Proposal for the [07] series of amendments to Regulation No. 48 (Installation of lighting and light-signalling devices)

The text reproduced below was prepared by the experts from Germany and Japan to reduce glare problems for drivers by imposing automatic levelling. The modifications to the existing text of the Regulation are marked in bold for new or strikethrough for deleted characters.

Model A

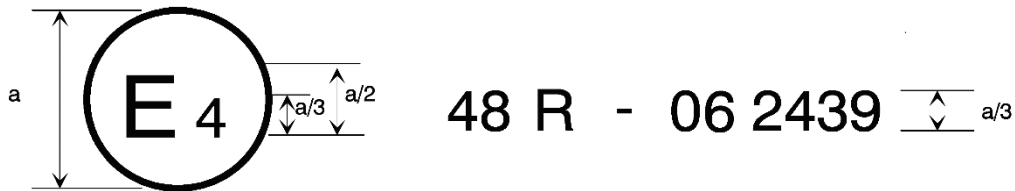
Annex 2, amend to read:

The above ... Regulation No. 48 as amended by the **07** series of amendments. The approval number indicates that the approval was granted in accordance with the requirements of Regulation No. 48 as amended by the **[07]** series of amendments.

Model B

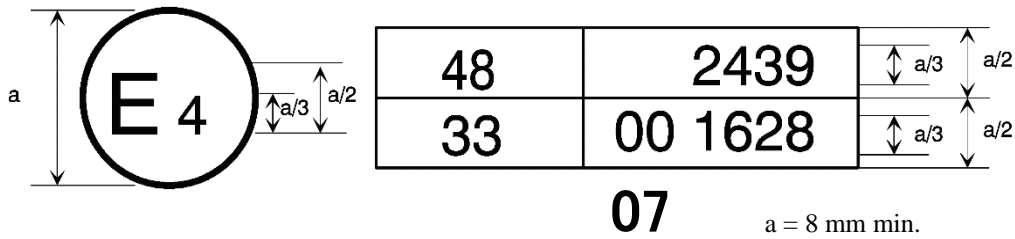
The above ... Regulation No. 48 as amended by the **[07]** series of amendments and Regulation No. 33.² The approval number indicates that, at the dates when the respective approvals were given, Regulation No. 48 was amended by the **[07]** series of amendments and Regulation No. 33 was still in its original form."
